The Long-term Radiological Safety of a Surface Disposal Facility for Low-level Waste in Belgium

An International Peer Review of Key Aspects
of ONDRAF/NIRAS' Safety Report
of November 2011 in Preparation for
the License Application

© OECD 2012
NEA No. 7086

Figure 3.4: Schematic view of the disposal system and the multi-layer cover components (ONDRAF/NIRAS 2011f)

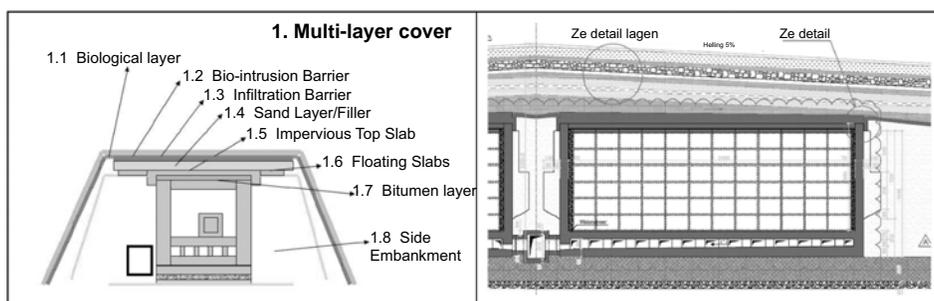
The IRT considers that it would be helpful, in due course, to provide additional information on the expected performance of each of the cover components over time and on any (e.g. physical, chemical) interactions between them; this would improve confidence in estimates of the long-term performance of the cover. Disposal facility construction and operation would precede cover emplacement and so there would be time to conduct tests on the cover and its components as the disposal programme progresses.

The IRT notes that, in accordance with the proposed design, it is ONDRAF/NIRAS' intent to monitor the integrity of the cover and the filled modules via the drainage system and the inspection rooms and galleries in the base of the modules. The IRT notes that the drains in the base of the modules might only provide an indirect indication of cover performance – this is part of the reason for the recommendation to consider including a water collection system in the cover (see above).

The IRT notes the need for the facility to include multiple safety functions and defence-in-depth. The IRT considers that the possibility of backfilling the inspection rooms with a zeolite-based material at the time of closure is promising (because zeolite phases, such as chabazite, are known to occur and may be stable over the long term within degrading cementitious materials, and because zeolites are known to have good sorption properties) and might add further defence-in-depth to the design. The IRT recommends that ONDRAF/NIRAS should continue research into the possibility of backfilling the inspection rooms with alternative materials in order to add further defence-in-depth to the design. The feasibility of methods to emplace such backfill materials and the possible interactions between them and the wastes and concretes of the disposal facility would need to be considered as part of ONDRAF/NIRAS' RD&D programme.

Figure 3.5: Schematic view of the Type I (left), Type II (centre) and Type III (right) caissons containing different waste types (ONDRAF/NIRAS 2011f)

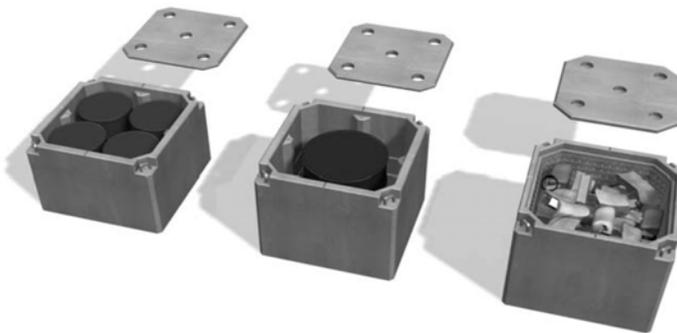
The IRT notes that simply stating the values of the safety factors used/assumed without explaining how the safety factors were selected would not allow readers to understand how much safety margin has been allowed for in the calculations. A similar comment may also be made on Section 7.4.4, which discusses the loads on the caissons and monoliths, and the different situations that have been considered in the designs. The various loads and situations are listed, but no justification or reference to supporting documentation is provided. Although the lack of such explanations may have no implications for the designs of the waste packages, explanations should be provided in the Safety Report to allow readers to understand why the particular situations and safety factors were considered (e.g. why is 0.85 used to assess the long-term effect of the load, or why a dynamic load of 1.15 is considered?).

Figure 3.8: ONDRAF/NIRAS’ synthesis of calculated radiological impacts for different scenarios (Minon, 2012b)

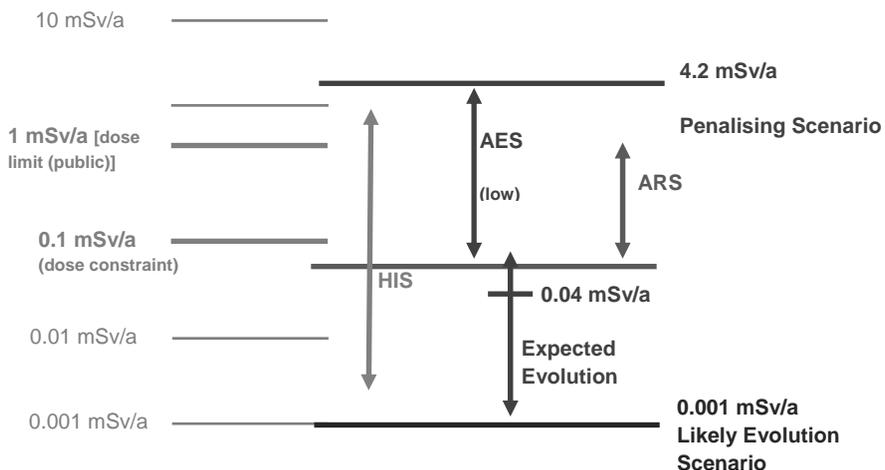
Based on the results that have been seen by the IRT, it is noted that the calculated safety of the disposal system does not appear very sensitive to variations in the values of numerous parameters. However, the IRT notes that some assessment cases have a higher sensitivity to key parameters and that those cases seem to be linked to the characteristics of the cementitious components e.g. the hydraulic conductivities of the concrete barriers. The IRT notes that on-going RD&D programmes should contribute, in due course, to improving knowledge, understanding system performance, reducing uncertainty, increasing confidence in safety margins, and optimising the system.

The IRT observes also that, in the safety assessment, ONDRAF/NIRAS has made reference to the international ICRP recommendations (ICRP-103) for radiological impact calculations. The calculated radiological impacts in the safety report, as well as other later calculations, are within the ICRP allowed ranges for the various different scenarios, including the “penalising scenario”, and are illustrated in Figure 3.8. The IRT, however, has questioned some assumptions made by ONDRAF/NIRAS and has suggested additional calculations, which may or may not confirm the results of the current assessment.
